## AMENDMENT

USSN 10/649,220  
10710/622 (PTG 1083 PUS)  
Response to March 9, 2006 Office Action

### Annotated Marked-Up Drawing

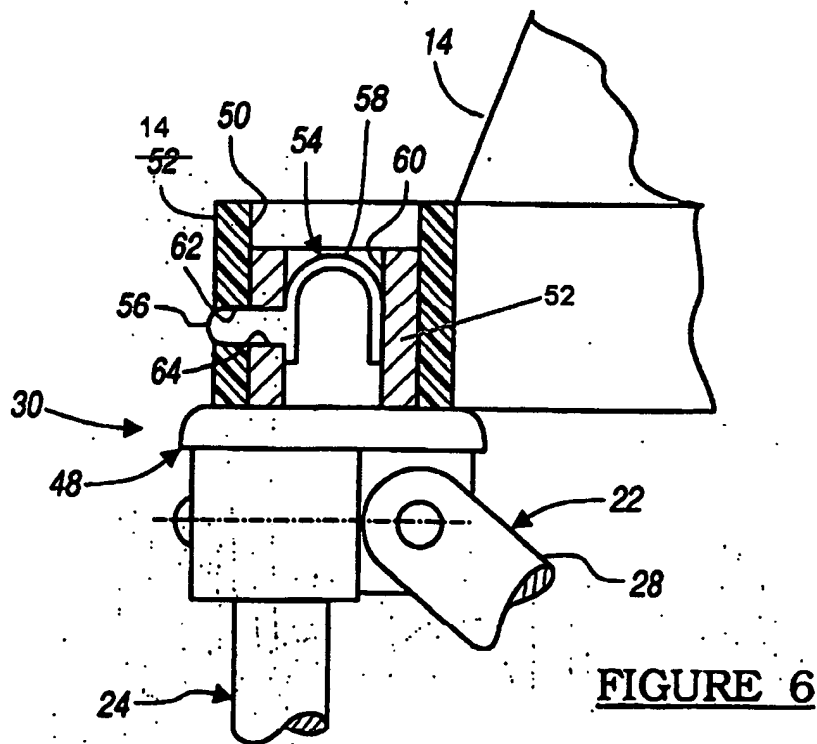
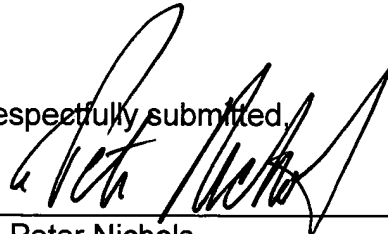
A replacement sheet of drawings including changes to Figure 6 is attached and an annotated copy of Figure 6 identifying changes made is included below. Specifically, Figure 6 has been amended to change original reference numeral 52 to 14 and to add reference numeral 52 to indicate the location of the pivot block projection 52 within the bore 50. Support for the amendments is found in the originally filed application, for example, at paragraph [0030]. No new matter has been added. The Applicant believes that the objections to the drawings and the specification are now moot. Applicant respectfully requests that objections to the specification and drawings be withdrawn.

As an initial matter, the Examiner still objected to the drawings. Figure 6 has been modified to replace original reference numeral 52 with reference numeral 14. In addition, reference numeral 52 was added with a lead line to indicate that the lightly cross hatched element positioned between the darker cross-hatched element and the wave spring 58 is indeed the pivot block projection. Applicant also contends that the objection to the specification is unwarranted because the pivot block projection 52 is indeed that feature projecting from pivot block 48 in Figure 2 and 3. Figure 6 is a partial cross section of a corner of the saw base and thus pivot block projection must be and is shown and is identified with reference numeral 52. Applicant contends that the amended Figure 6 is consistent with each of the other Figures and with the specification. Therefore, Applicant requests approval of the drawings and withdrawal of the objection to the specification.
